NEWMAR CORP <i>P.O. Box 30,</i> Nappanee, IN. 46550 UNITS: INCHES TITLE BLOCK: 1-5TB	Model: KG DB	Sheet 7 OF 12	Drawn by: R. P.	Checked by: B. L. G.	Revision: ADDED 2 STANDOFFS; 21-3/8" FROM ENDS ON CENTER LINE ON LARGE	By: K. B.
	Title: RECESSED CEILING PARTS, METAL	I.D. # 2021\ HE\ROOF\PARTS\ KG_REC_CEILING	Date: 8/20/19	Date: 5/18/20	CEILING FEATURE & 1 ON CENTER, BEDROOM CEILING FEATURE. (ECO #538)	Date:BLG 10/19/21
					Revision: ADD 21KG CEILING KIT-METAL, PART NUMBER #154521, ADD METAL PLATE	By: R. F. P.
					TO SUPPORT REMOVABLE VENTS, REVISE TITLES ON EACH SHEET, (PCR #211145)	Date:BLG 7/29/20

Model:
KG DB

Title:
RECESSED CEILING PARTS, METAL

Sheet
8 OF 12

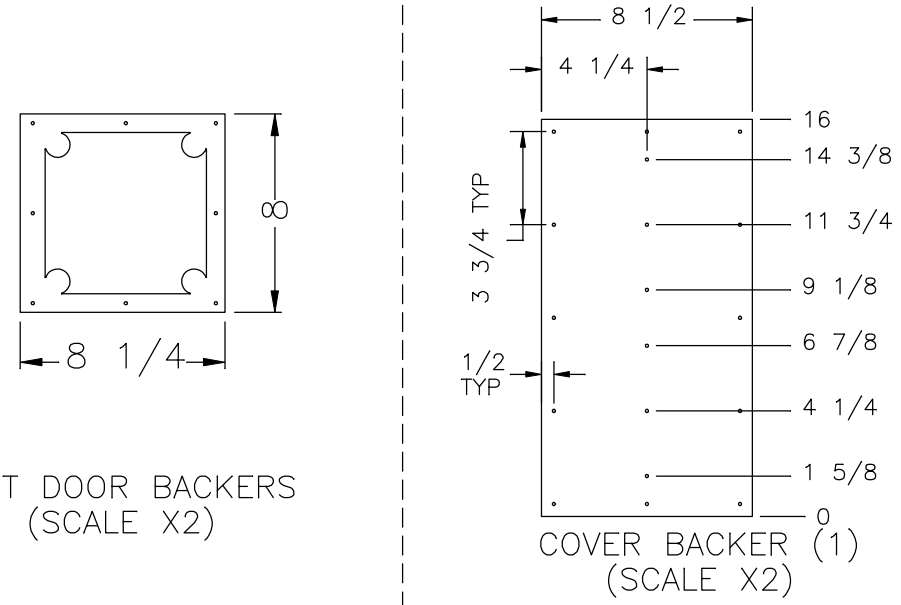
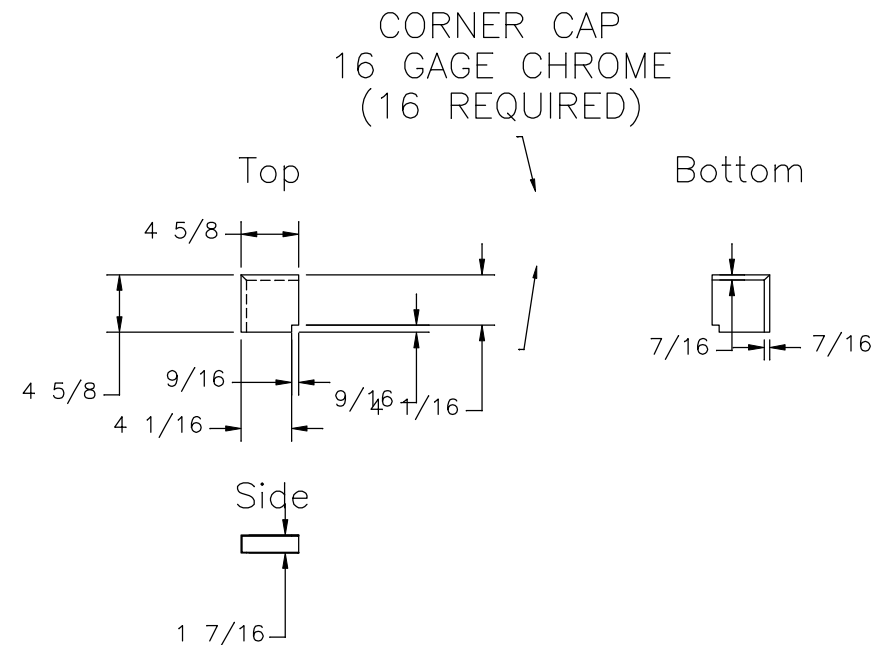
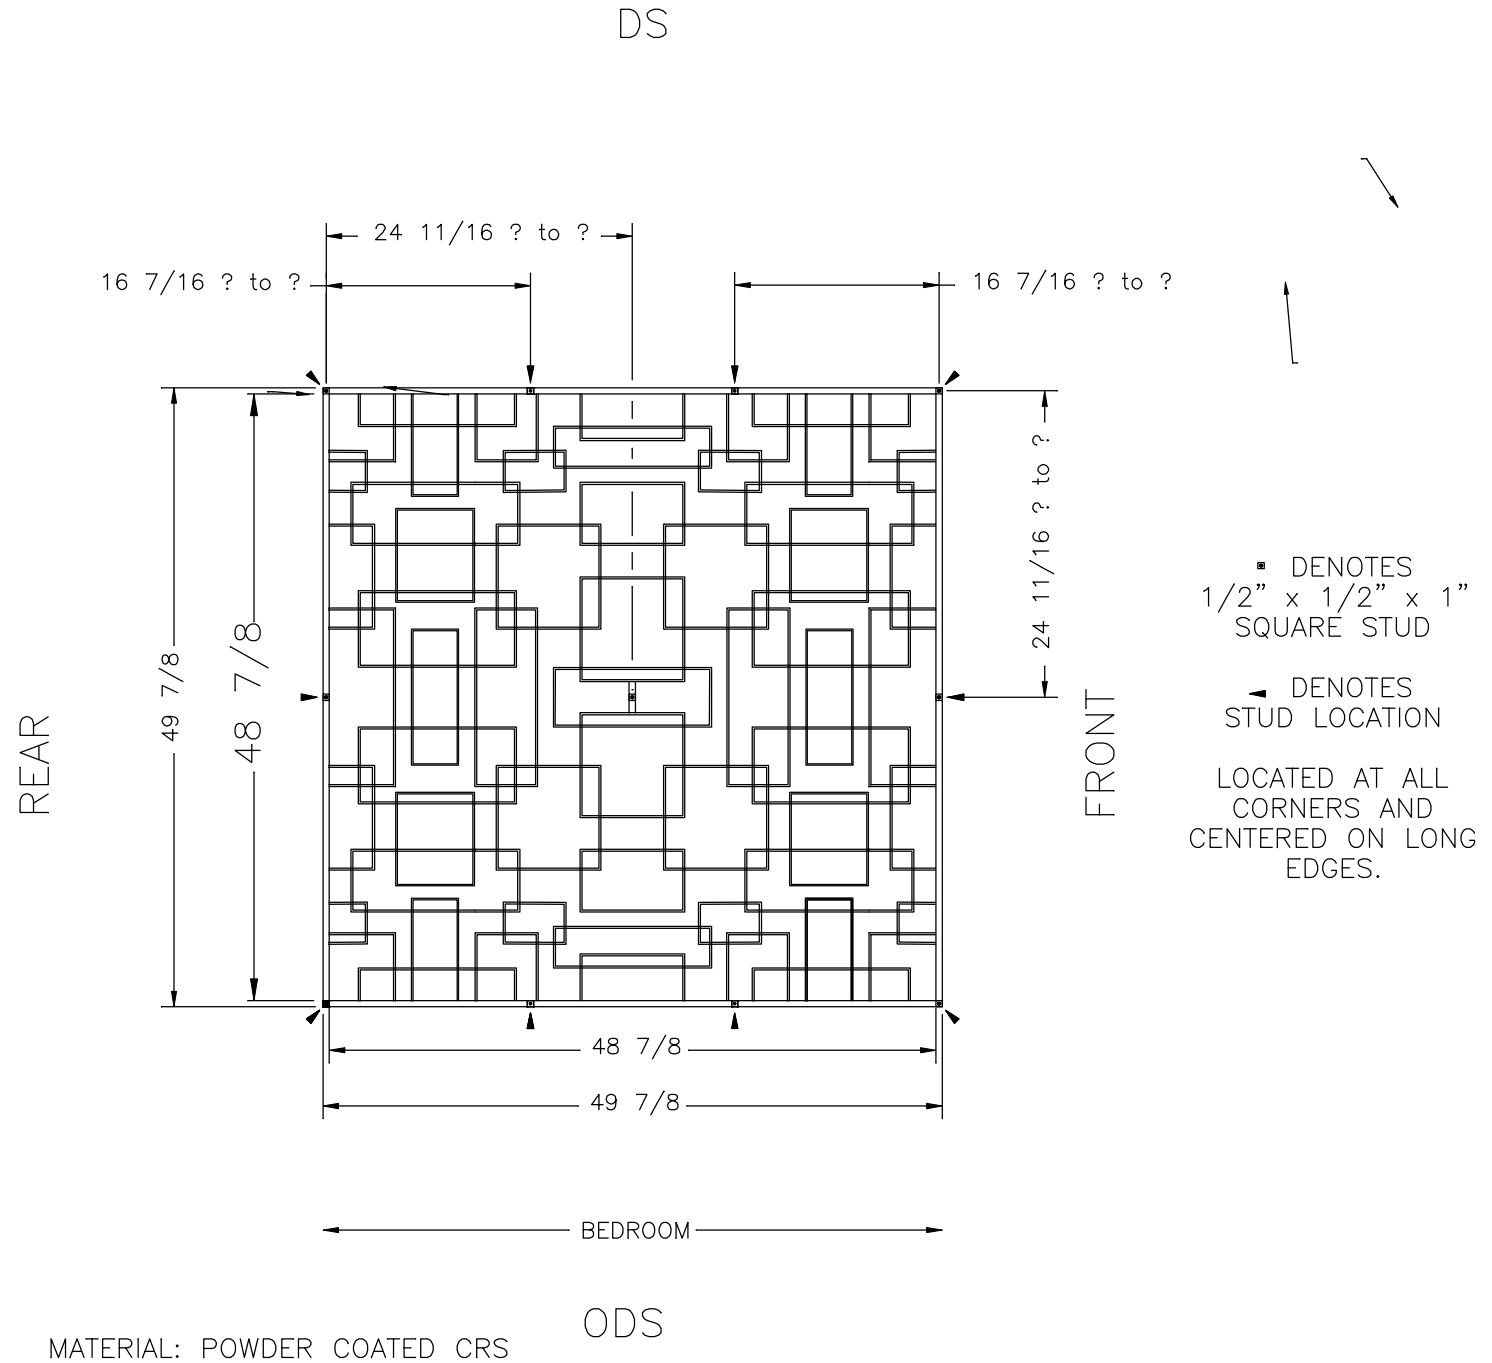
Revision: ADDED 2 STANDOFFS; 21-3/8" FROM ENDS ON CENTER LINE ON LARGE
CEILING FEATURE & 1 ON CENTER, BEDROOM CEILING FEATURE. (ECO #538)

Revision: REVISED LARGE LIVINGROOM CEILING FEATURE; ADDED TWO (2) ADDITIONAL
OPENINGS AND A BACKER TO SECURE PANEL TO RAFTER. (ECO #720) (PCR #220060)
